Midpeninsula Regional  
Open Space District

R-26-43  
Meeting 26-10  
April 8, 2026

Addendum to the Bear Creek Redwoods Preserve Plan Environmental Impact Report for the Bear Creek Redwoods North Parking Lot Project.

# **ADDENDUM TO THE BEAR CREEK REDWOODS PRESERVE PLAN ENVIRONMENTAL IMPACT REPORT**

**Table 1 – Comparison of Preserve Plan Concept to Preferred Concept**

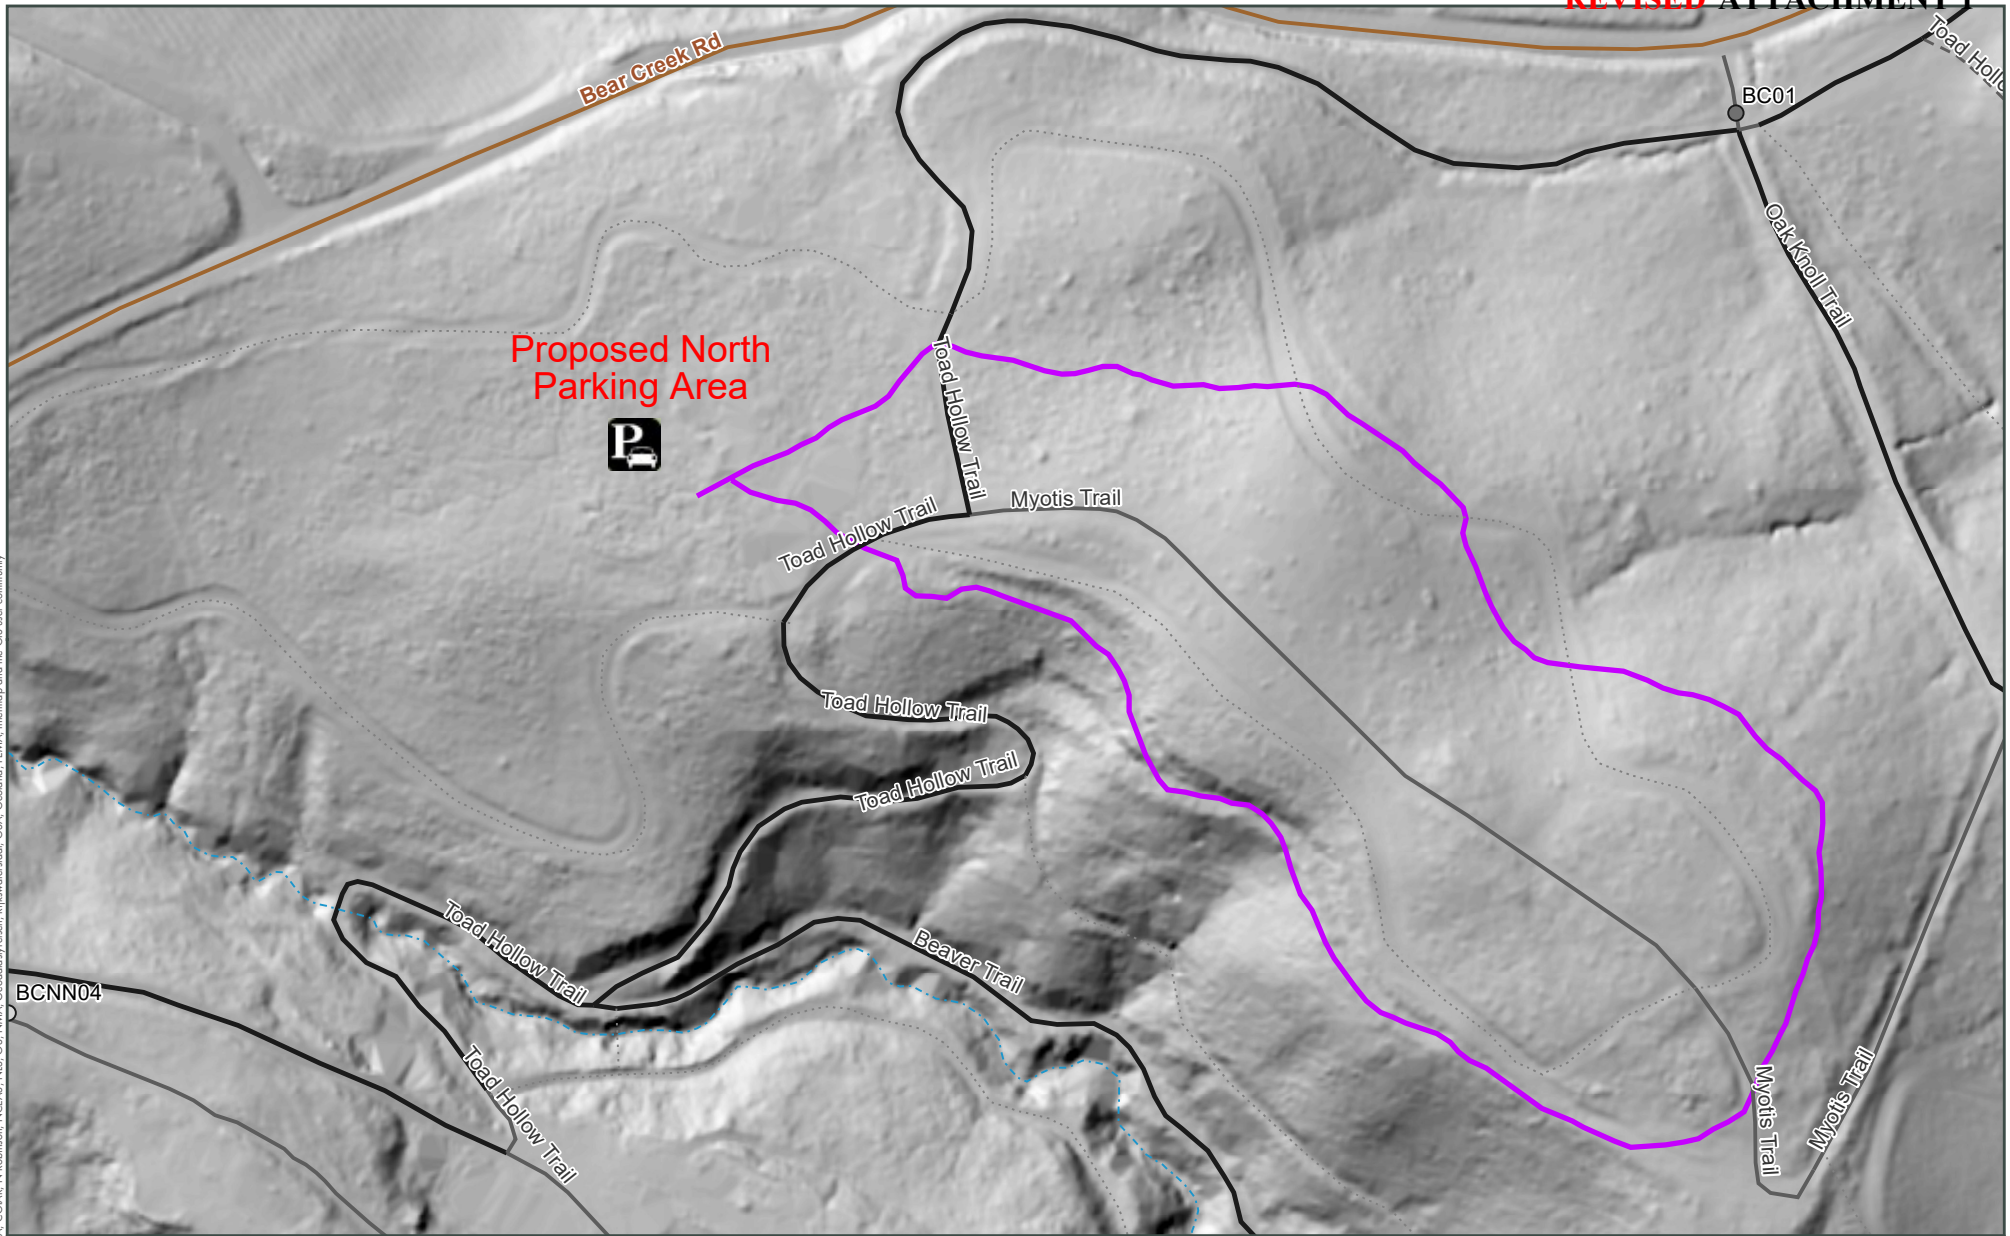
The proposed modifications to the Preserve Plan Concept for the North Parking Area include a change in shape of the parking area and a shift of a portion of the footprint approximately 270 feet to the east<sup>1</sup> into a flatter area that provides more visual screening from the roadway by existing trees. The Preferred Concept includes 44 vehicle spaces and six equestrian stalls; however, the design builds in programmatic flexibility by allowing the ability on a case-by-case basis to repurpose one or two of the equestrian stalls with up to nine angled standard parking stalls to support special events, or repurpose two parallel equestrian stalls for use by a shuttle or buses to support specific group programs at Bear Creek Stables. If the two equestrian stalls were repurposed, the Preferred Concept could accommodate a maximum of 57 spaces (53 parking spaces and four equestrian stalls). The Preferred Concept would require fewer retaining walls, and result in less impervious surface due to a smaller parking area footprint. Both concepts site the driveway in the same location to provide sufficient line of sight. Other elements in the modified project include electric vehicle (EV) charging infrastructure using existing utility connections, stormwater treatment facilities, picnic tables, a vault restroom, bike racks, an entrance sign, and interpretive signage. Table 1 summarizes differences between the Preserve Plan Concept and Preferred Concept for the North Parking Area.

Component	Preserve Plan Concept	Preferred Concept
Parking Capacity	51 vehicles	44 to 53 vehicles
Horse Trailer Parking	8 reverse parking trailer spaces	4 to 6 pull-through trailer parking spaces
Total (potential) Parking Spaces	59 spaces	57 spaces (53 vehicles and 4 horse trailer parking spaces)
Approximate Retaining Wall Requirement	1,000 linear feet	185 linear feet
Approximate Impervious Surface	46,000 square feet	38,700 square feet
Total Tree Removal	8 trees	15 trees
Trees 6-11 inches diameter at breast height (dbh) to be Removed	Not specified at the time of concept plan	11 trees
Trees 12-15 Inches dbh to be Removed	Not specified at the time of concept plan	3 trees
Trees 16+ Inches dbh to be Removed	Not specified at the time of concept plan	1 tree

<sup>1</sup> The Preserve Plan Concept and Preferred Concept are different shapes and overlap in location. The Preferred Concept stretches further east than the Preserve Plan Concept.
